MONTGOMERY COUNTY HISTORIC PRESERVATION COMMISSION
STAFF REPORT

Address:	8000 Overhill Lane, Bethesda	Meeting Date:	1/8/2025
Resource:	Contributing Resource (Greenwich Forest Historic District)	Report Date:	12/31/2024
Applicant:	Anil Gupta & Haiyan Wang Luke Olson, Architect	Public Notice:	12/25/2024
Review:	Historic Area Work Permit	Tax Credit:	n/a
Permit No.:	1040897 REVISION	Staff:	Dan Bruechert
Proposal:	Revision to previously approved HAWP for hardscape, fenestration, and porch roof alterations.

Figure 6: Approved left addition (note, there was a drafting error at the basement level).

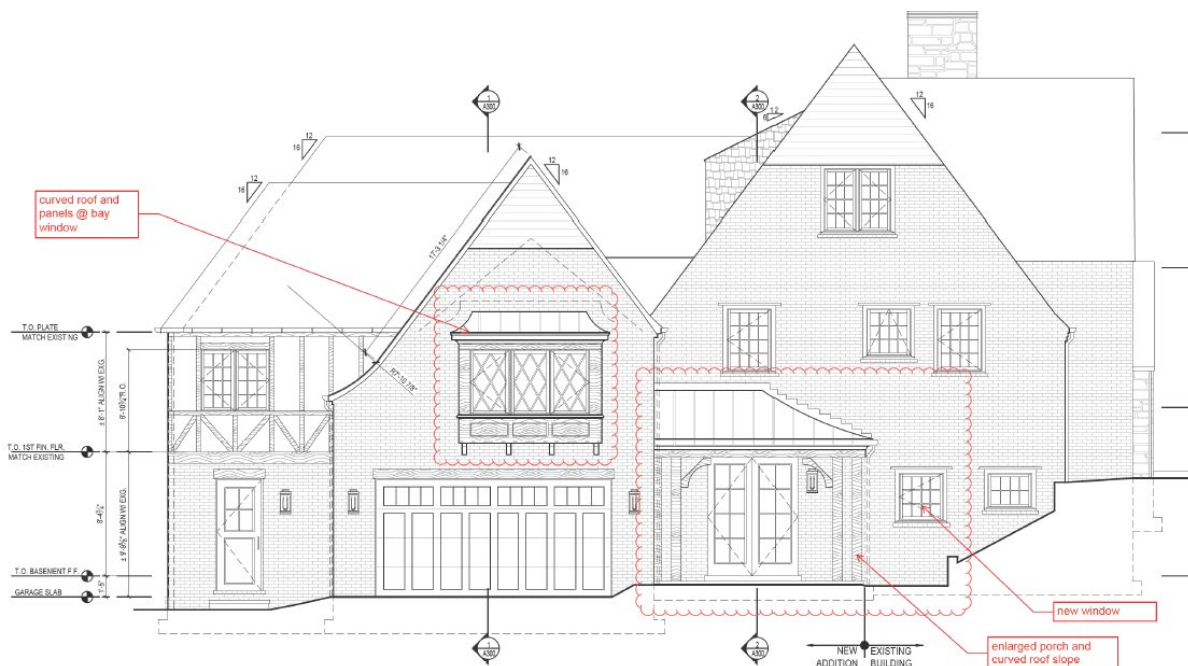
The approved roofs over the approved bay window and basement-level porch were both standing seam copper with hips in the corners. The applicant proposes to revise these roofs so that the corners have a curved hips. Additionally, the basement porch roof will be widened by 1' (one foot). The applicants propose to expand the existing brick walkway to access this slightly enlarged porch. The proposed path is approximately 5' (five feet) long and 3' (three feet) wide.

Staff finds the proposed basement-level will be minimally visible from the public right-of-way; and its visibility will be further reduced by the landscaping on site. While the HPC generally attempts to avoid installing new window openings in historic houses, a more lenient approach is given for windows on the rear and at the foundation level, because they typically do not contribute to the houses' significant historic features. Staff finds that to be the case in this instance. Staff additionally finds the proposed window is compatible with the house's materials and design. Staff recommends the HPC approve the window installation under 24A-8(b)(2) and (d), the *Design Guidelines*, and *Standard 2*.

Staff finds the proposed roof line alteration for the bay and the porch is more in keeping with the character of the house's historic Tudor Revival architecture. The revised design is consistent with the copper porch roof at the front door (see below). Additionally, as new features, these alterations will not little-to-no impact on the historic character of the house. Staff further finds the porch enlargement is only

nominally bigger and its larger size will not substantially impact the character of the house or surrounding historic district. Staff recommends the HPC approve the roof alterations under 24A-8(b)(2) and (d), the *Design Guidelines*, and *Standard 2*.

Sheet Title
LOWER LEVEL PLAN

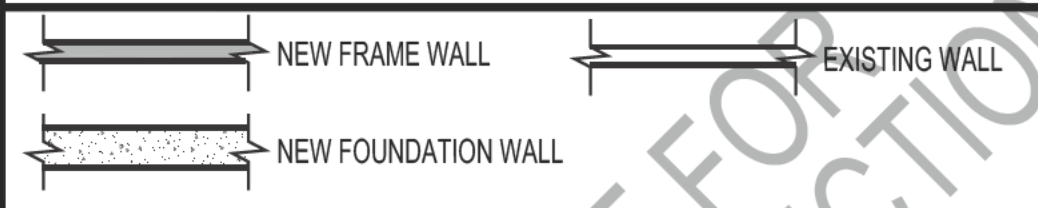
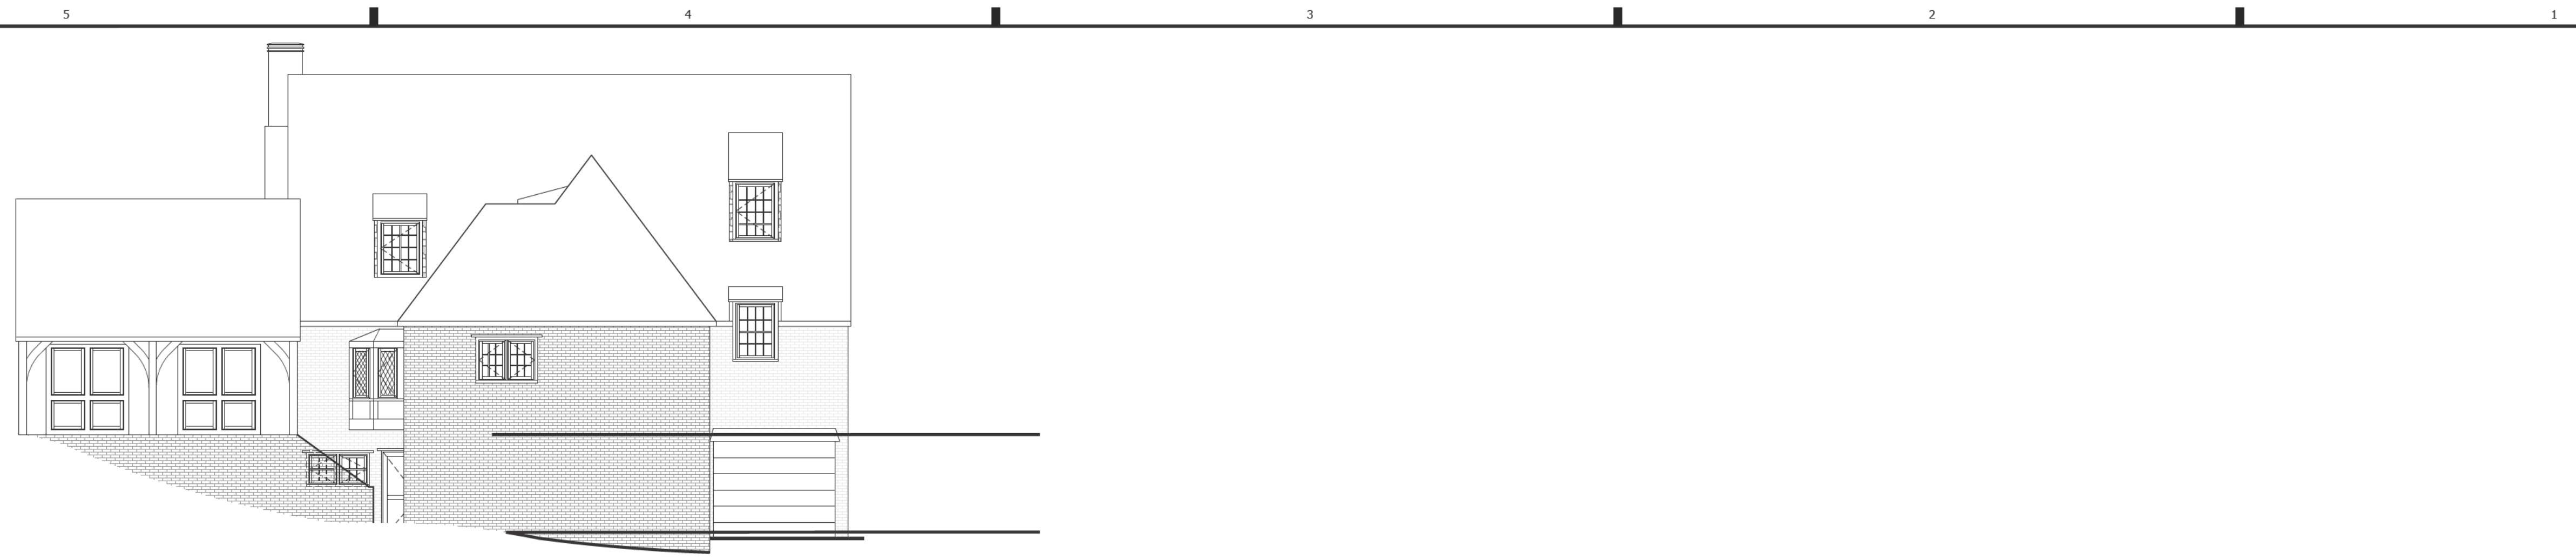
- 1.) ENLARGE THE LOWER LEVEL COVERED PORCH BY 1' IN WIDTH AND 1' IN DEPTH, NEW DIMENSIONS TO BE 14'-1" BY 5'-0"
- 2.) MODIFY THE LEFT SIDE BAY WINDOW AND COVERED PORCH ROOFS TO HAVE A CURVED SLOPE SIMILAR TO THE CANOPY ROOF OVER THE FRONT DOOR
- 3.) ADD A WINDOW TO LEFT SIDE ELEVATION IN LOWER LEVEL GUEST BEDROOM
- 4.)ADD A WINDOW TO REAR ELEVATION IN THE LOWER LEVEL MUDROOM OF NEW 2-CAR GARAGE ADDITION WING
- 5.) ADD A WINDOW TO THE REAR ELEVATION IN THE LOWER LEVEL EXERCISE ROOM/GUEST ROOM. THIS WING OF THE HOUSE IS PART OF A PREVIOUS ADDITION.
- 6.) ENLARGE THE RIGHT SIDE WINDOW IN THE LOWER LEVEL EXERCISE ROOM TO BE A TALLER WINDOW WITHIN THE SAME MASONRY OPENING WIDTH. THIS WING OF THE HOUSE IS PART OF A PREVIOUS ADDITION.

Sheet Title
REAR ELEVATIONS

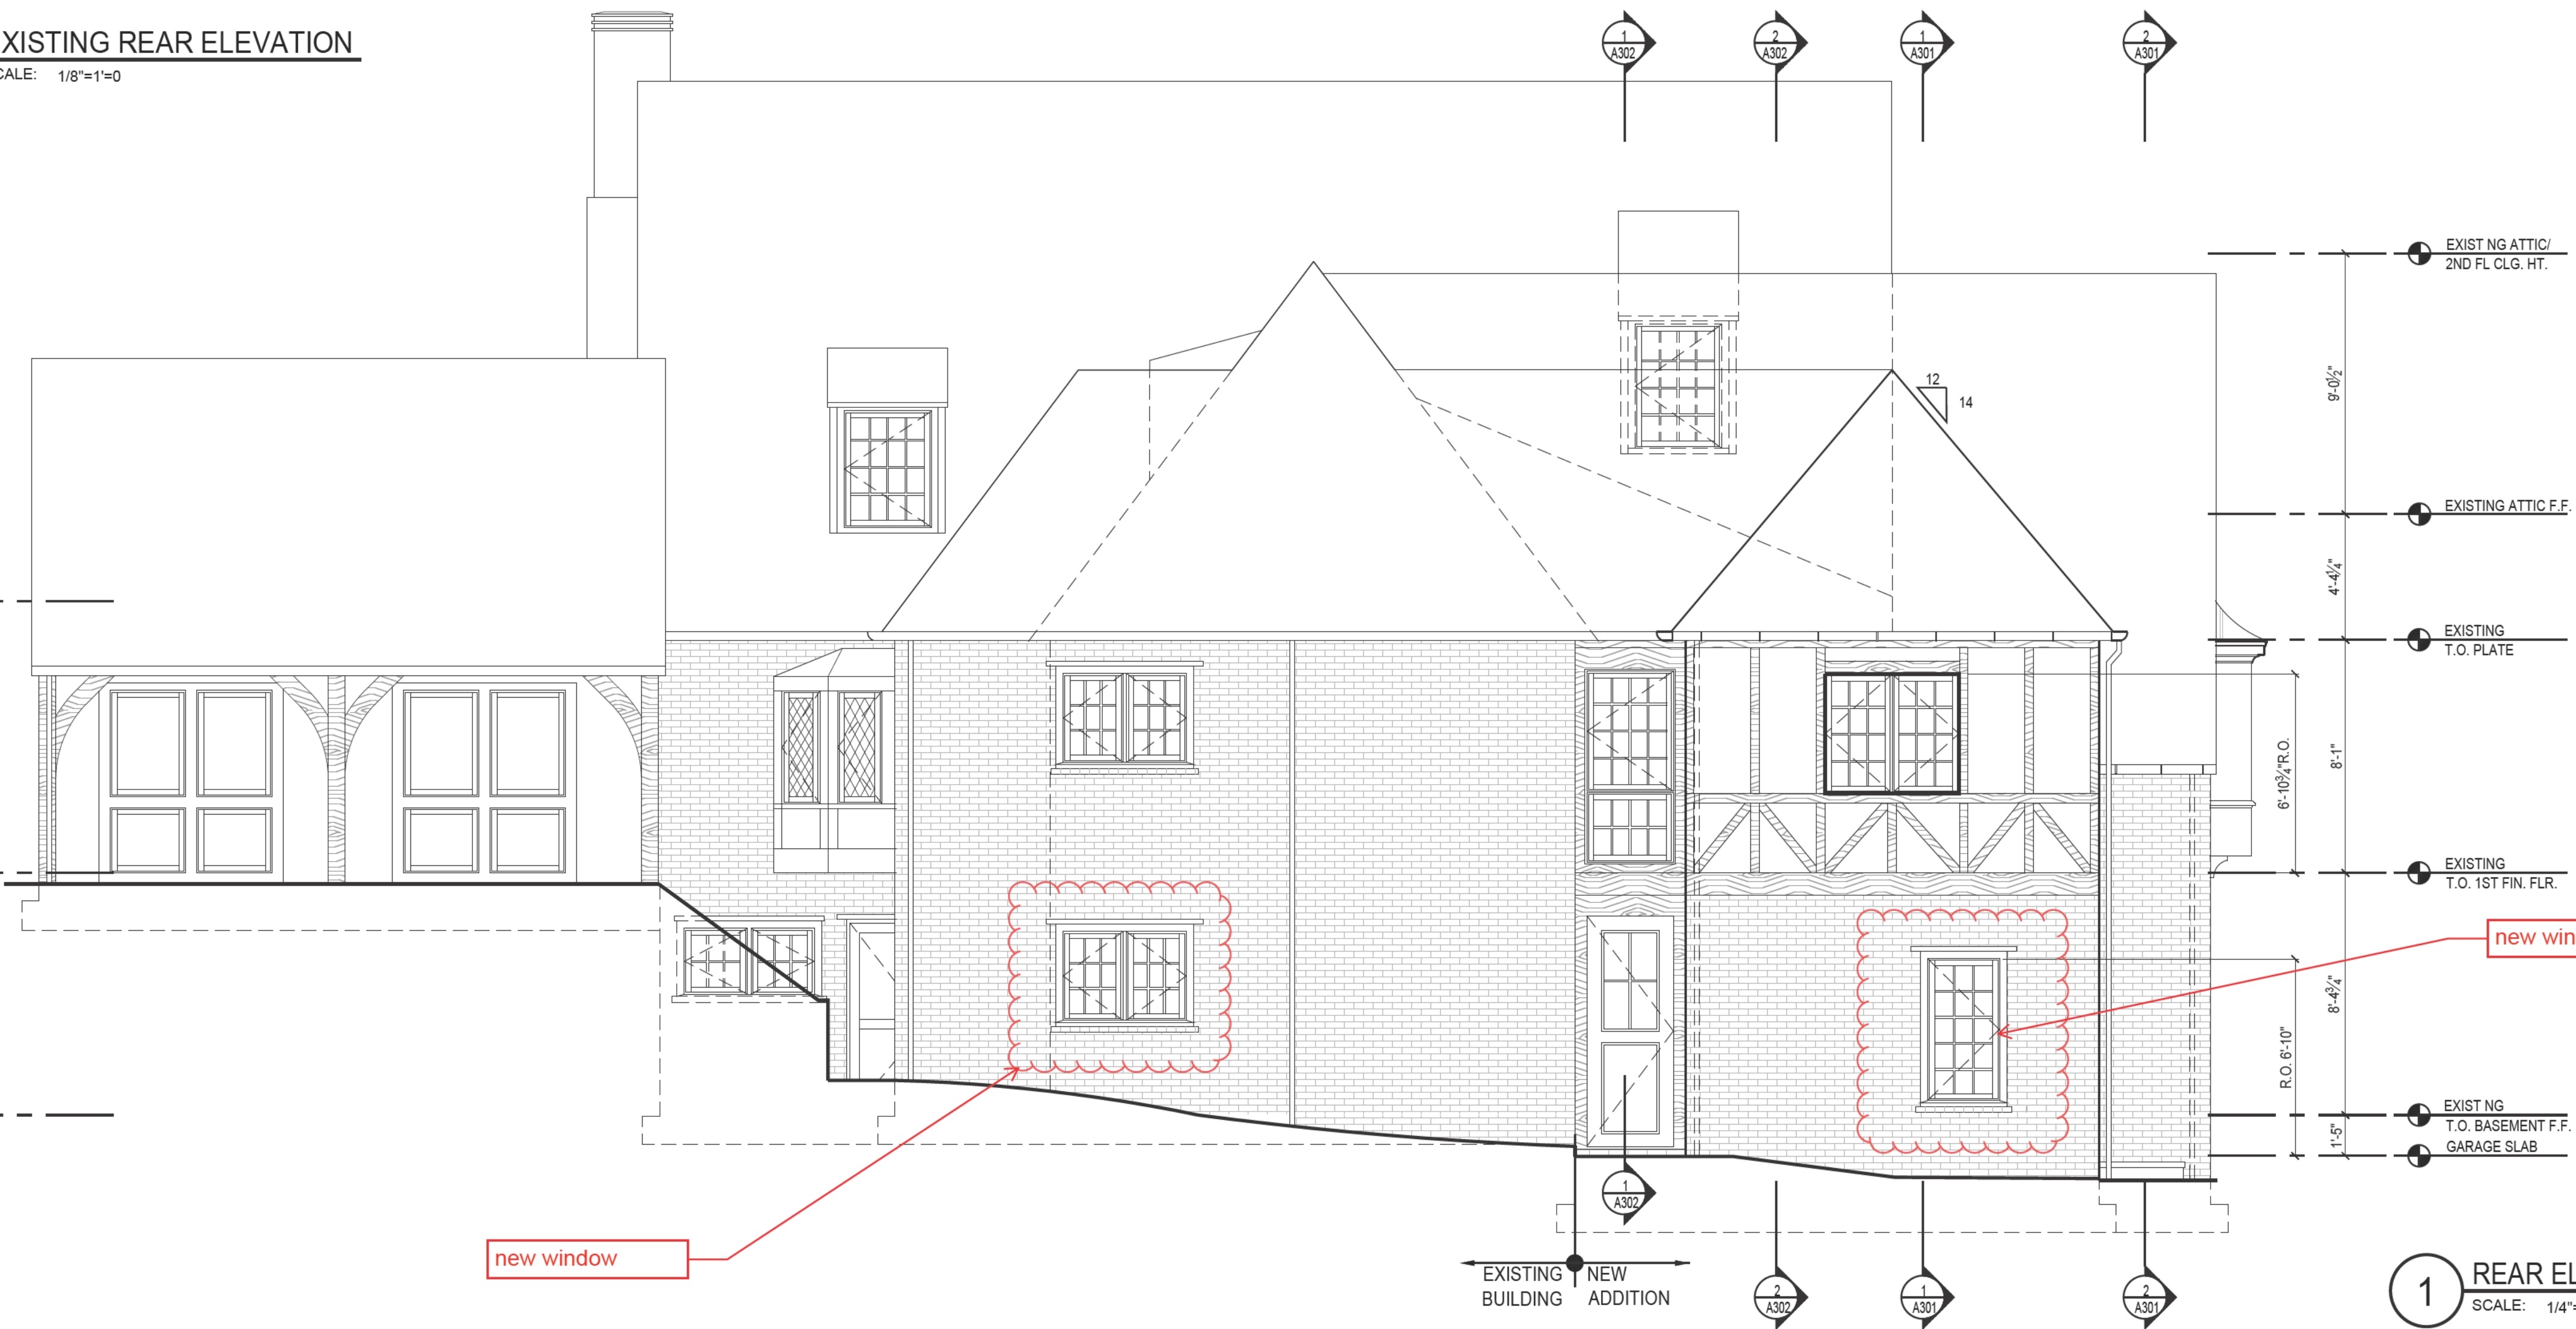
On the rear elevation, the applicant proposes to add two window openings to the basement level. The approved design included no openings at this level (see *Figure 4*). Staff was unconcerned about this, because the elevation faces towards the neighboring property and is not at all visible from the public right-of-way. On the left side of the basement wall—which is the existing non-historic addition—the applicant proposes to install a pair of nine-light casement windows that will match the appearance of the first-floor windows directly above. On the right side of the rear elevation, in the approved, but unbuilt addition, the applicant proposes to install a twelve-light casement window. Both windows will be Marvin Ultimate aluminum-clad wood windows.

Staff finds neither of the proposed windows will be visible from the public right-of-way and their installation should be approved as a matter of course. Having made that determination, Staff also finds that the proposed window is compatible with the house's design and materials and is the same window the HPC approved in 2017. Staff recommends the HPC approve the window installation on the rear elevation under 24A-8(b)(2) and (d), the *Design Guidelines*, and *Standard 2*.
